Glenmont Fire Station, Mandatory Referral, MR 2012007

Completed: 12/08/11

- Staff recommends **approval and to transmit comments** to the Montgomery County Department of General Services.
- No correspondence has been received on this application.

Final Concept Site Plan

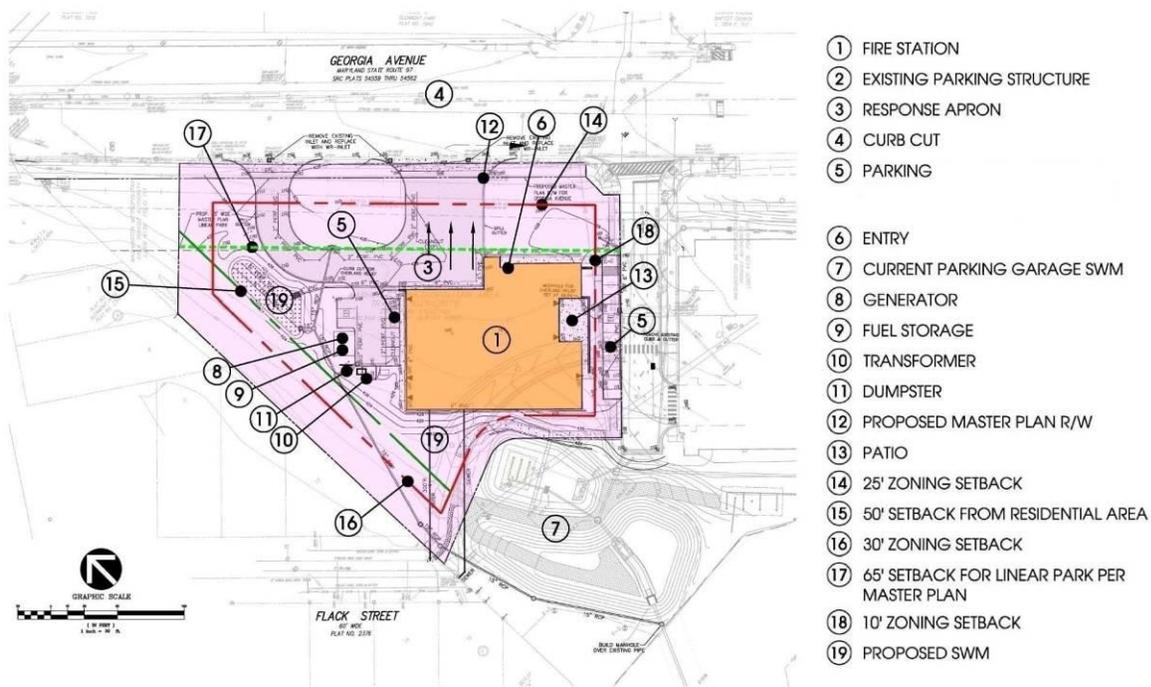
1. Satisfy the Policy Area Mobility Review (PAMR) test by paying \$24,400 towards a transportation infrastructure improvement within the greater Kensington/Wheaton Policy Area. The PAMR payment must be made prior to issuance of any building permit.

2. Provide an additional 2.5 feet of right-of-way along Georgia Avenue to accommodate the Georgia Avenue Busway based on 75 feet from the centerline, for a full right-of-way of 150 feet.

3. Coordinate with the Montgomery County Department of Transportation (MCDOT) and/or the Maryland State Highway Administration (SHA) on the following:
 - a. Provide the necessary traffic control measures such as flashing traffic signal at the fire station egress point onto Georgia Avenue, and a stop bar across the southbound lanes of Georgia Avenue.

- b. Obtain MCDOT approval for the perpendicular parking spaces proposed on Glenallan Avenue extended.
4. Provide the following regarding the proposed shared use path:

- a. Extend the shared use path along Georgia Avenue (Glenmont Greenway) to Denley Road to the north through the Washington Metropolitan Area Transit Authority (WMATA) property. This connection was recommended as a part of the Mandatory Referral No. 09737-WMATA-1 for the Glenmont Garage. Tie the shared use path into the existing sidewalk along Georgia Avenue frontage.

- b. Modify the existing shared use path at the southern edge of the intersection of Georgia Avenue and Glenallan Avenue (on the WMATA garage site) to align and connect with the crosswalk and the proposed path on the north side of the intersection.

5. Provide adequate space for the motorist leaving the last perpendicular parking space along the western side in the on-site parking lot north of the station.

6. Provide inverted-U bike racks near the main entrance to store at least four bicycles.
7. The applicant must widen the proposed sidewalk along the Glenallan Avenue frontage to be 8 feet wide to accommodate the Sector Planned bikeway connection between Georgia Avenue and Flack Street and curve this sidewalk around the on-street parking spaces instead of the proposed 90-degree turns.

8. Provide a sidewalk connection between the main entrance facing Georgia Avenue and the paved area in front of the apparatus bays for the motorists walking to/from the parking area.

**GLENMONT FIRE STATION FEASIBILITY STUDY
2 STOREY - 4 BAYS
OPTION 7**

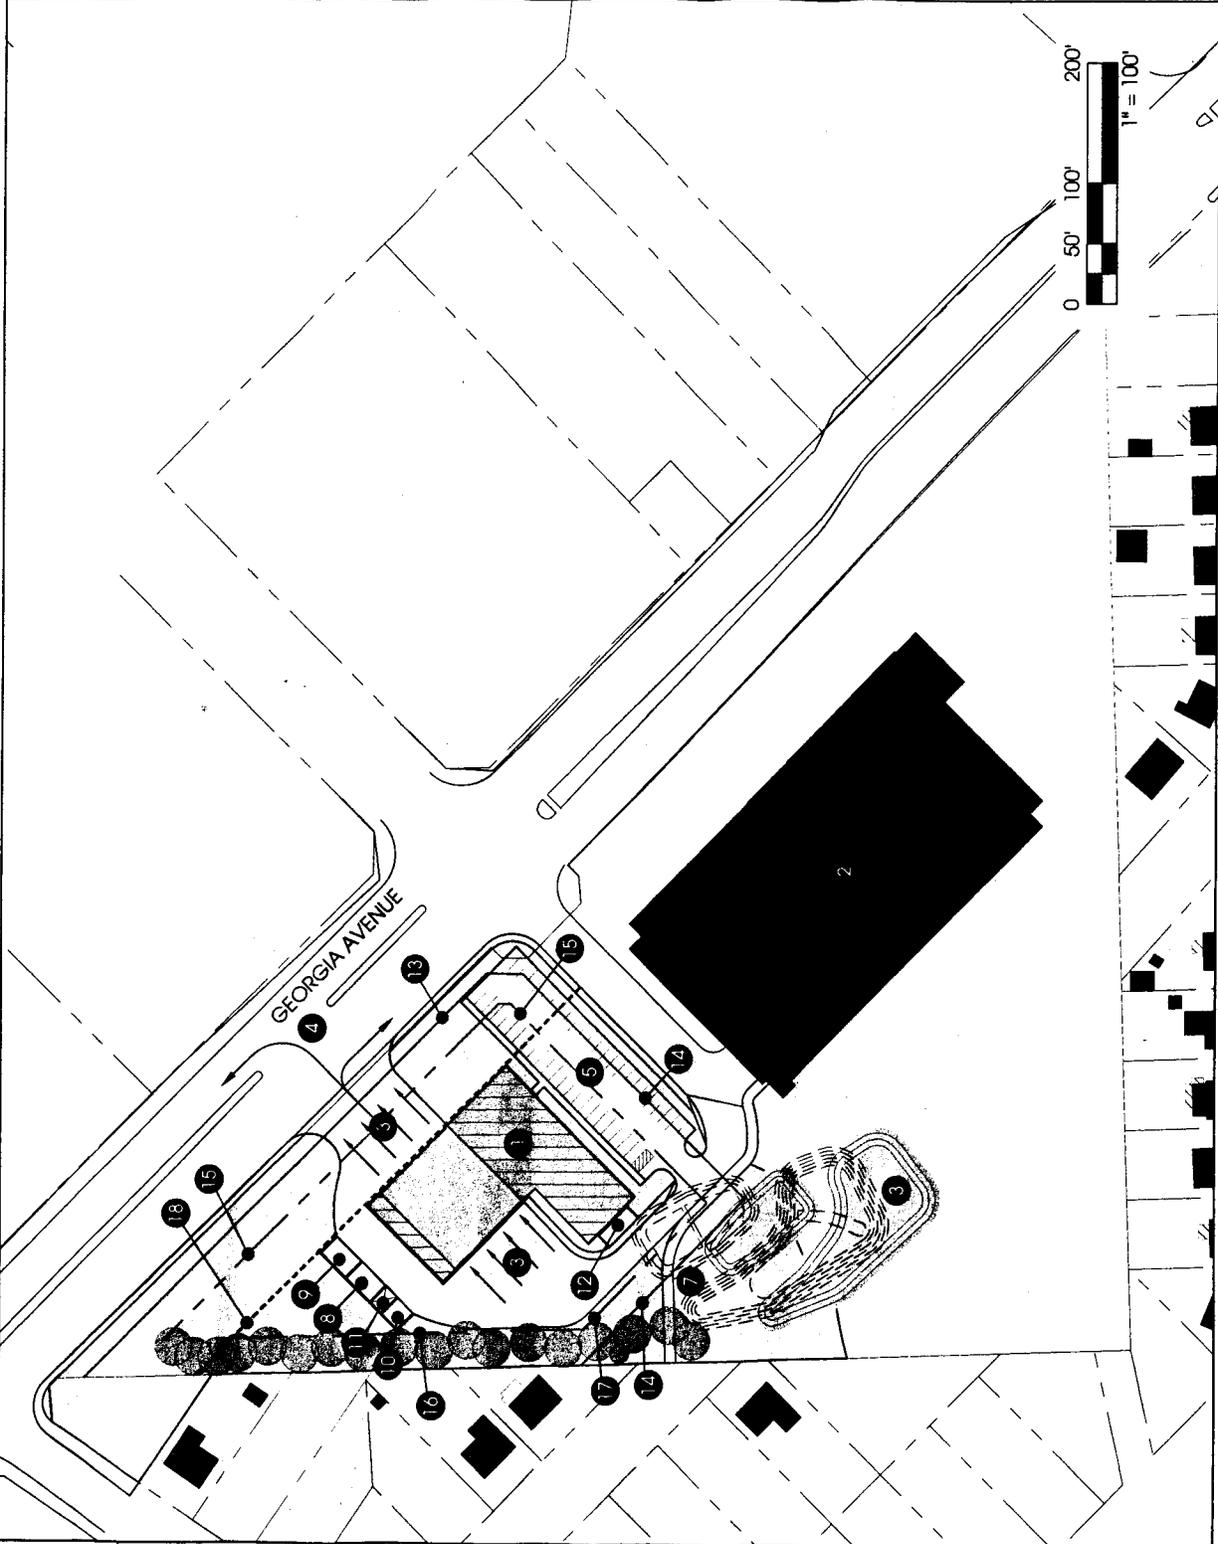
- The concepts have extensive impervious surfaces; consider accommodating some parking in the proposed parking structure.
- The planting area along the western property line appears narrow. Consider increasing the buffer to 50' conforming to that of the proposed parking structure.

- Option 7 supports the vision of the Georgia Avenue Enhanced Boulevard concept in the Glenmont Sector Plan; more greenspace is preserved, the neck of the curb cut is minimized and parking is located to the rear.

- The shared single access to the parking garage with the fire station creates a circulation concern. There should be a contingency plan for garage ingress/egress in cases of emergency and/or incidents on Georgia Avenue.

- Stormwater Management facilities are proposed to move south for both options. The SWM concept should be reconsidered to avoid additional forest clearing.
